CITY OF ALBUQUERQUE

RE: **Lot 3 Block 8 Unit 22**
Volcano Cliffs SAD 228
6420 Canavio Rd. NW
Grading and Drainage Plan
Engineers Stamp Date 5/12/2020 (D10D003E3)
Pad Certification Date: 8/24/2020

SUBMITTED FOR:		SHEET TITLE:		PROJECT NAME:		VOLCANO CLIFFS 6420 CANAVIO RD NW PULTE ID 18							
GRADING PERMIT		GRADING AND DRAINAGE PLAN											
SHEET NUMBER:		1 OF 1

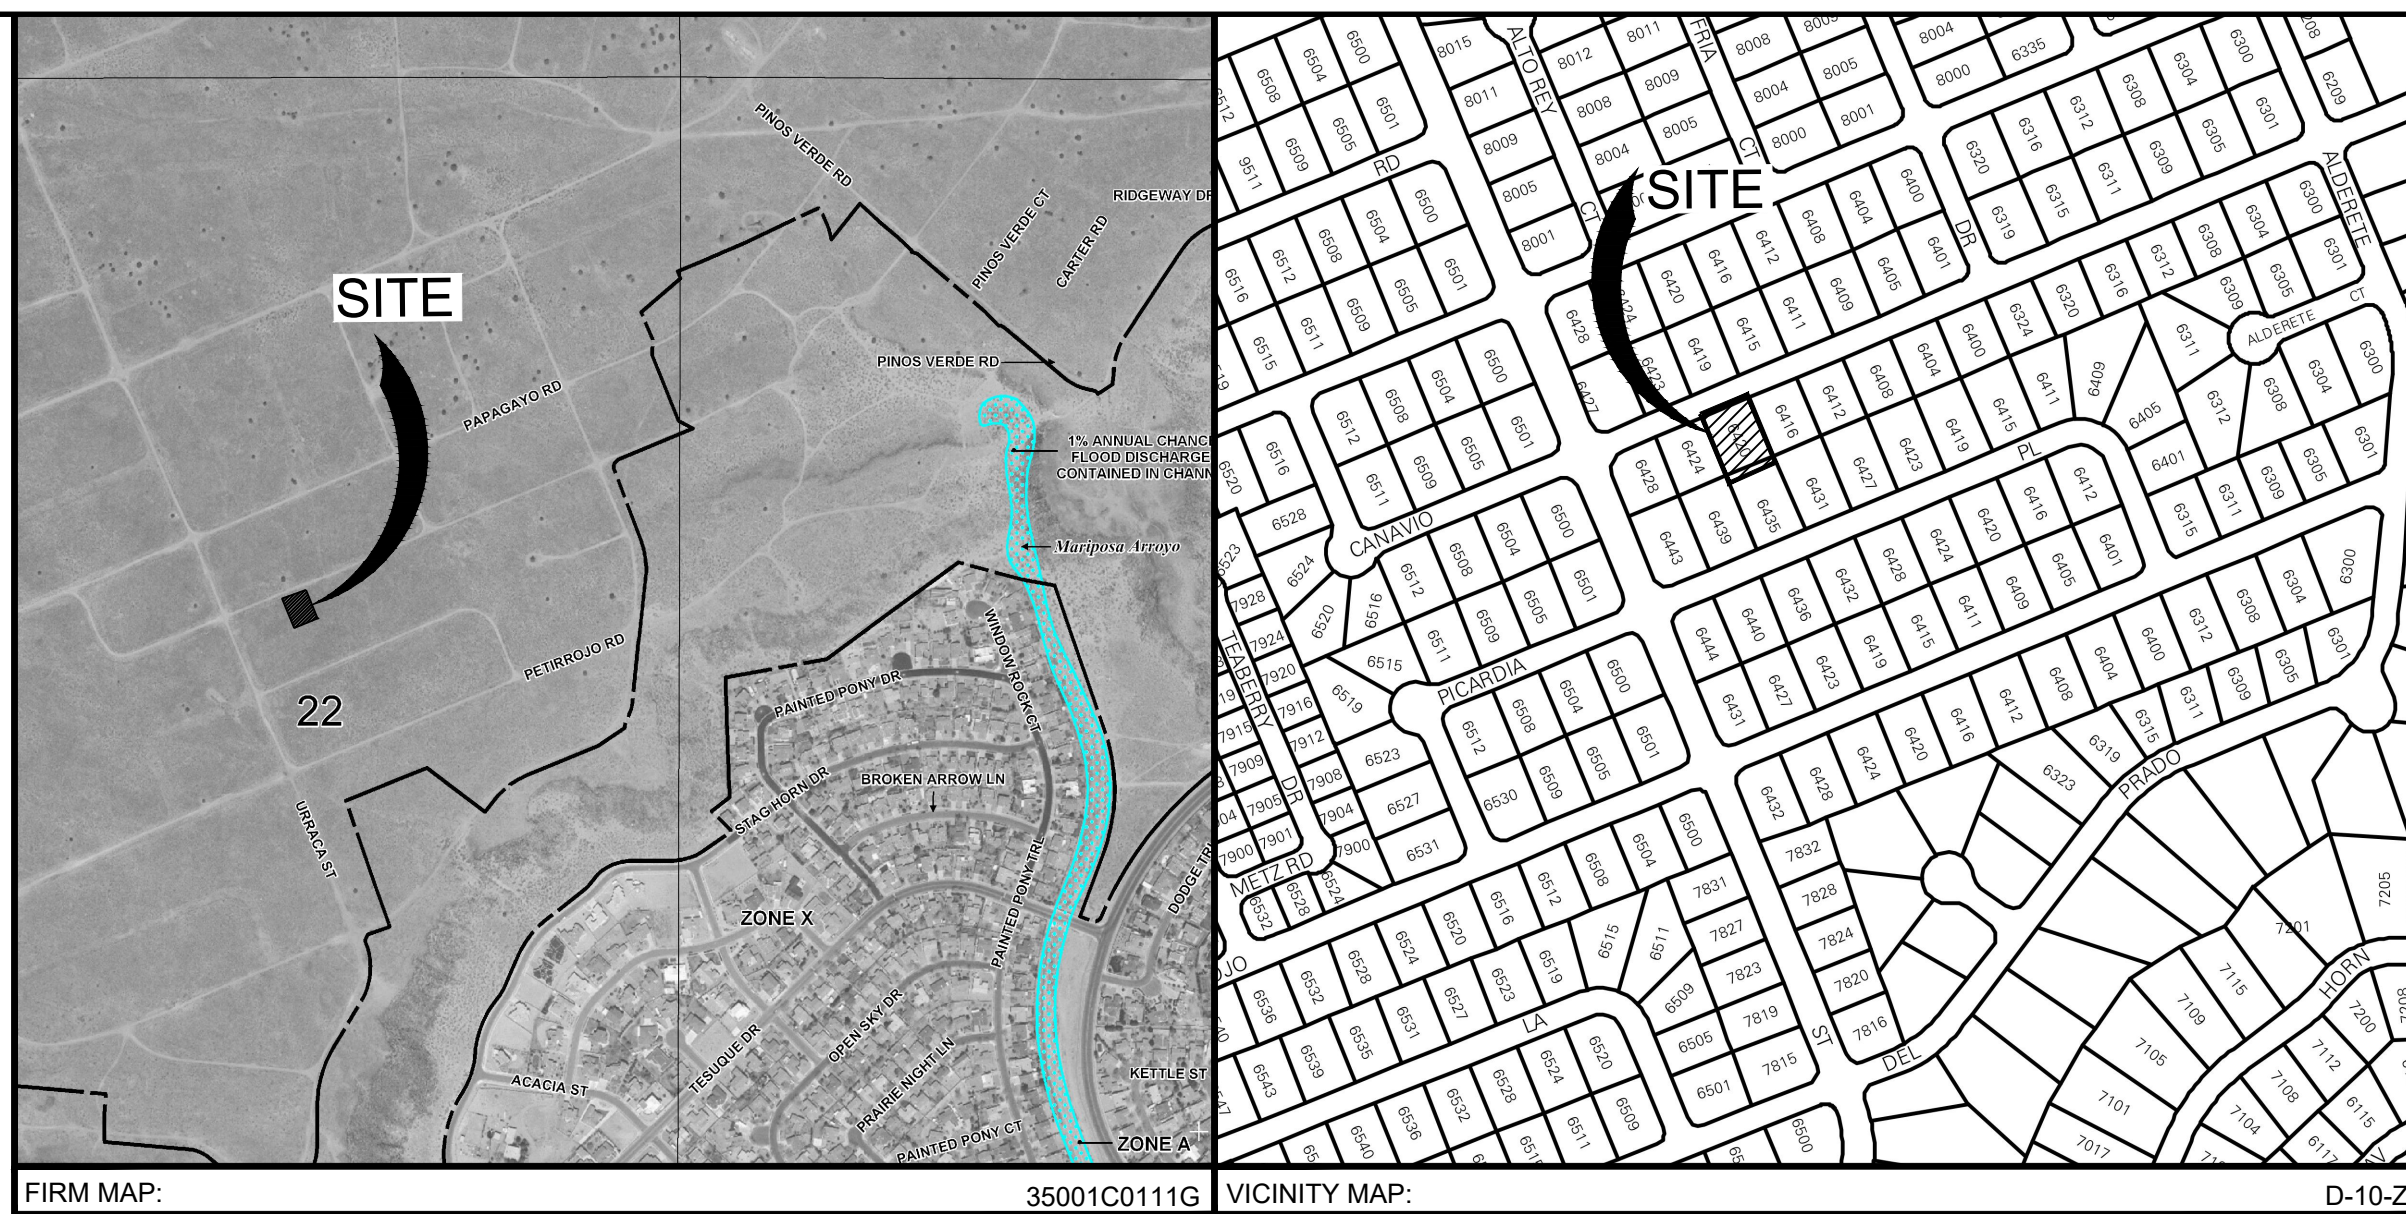
Based upon the information provided in your submittal received 9/25/2020, this plan is approved for Building Permit.

Prior to Building permit approval a Pad Certification will be required, provided by the Engineer or a registered Land Surveyor.

Reiterate to the Owner/Contractor that a separate permit for a garden/retaining wall must be obtained with the approved G&D plan and Pad Certification. **Also, if a swimming pool is to be added after this approval the grading and drainage plan will change and will need to be resubmitted.**

Prior to Certificate of Occupancy release, Engineer Certification per the DPM checklist will be required.
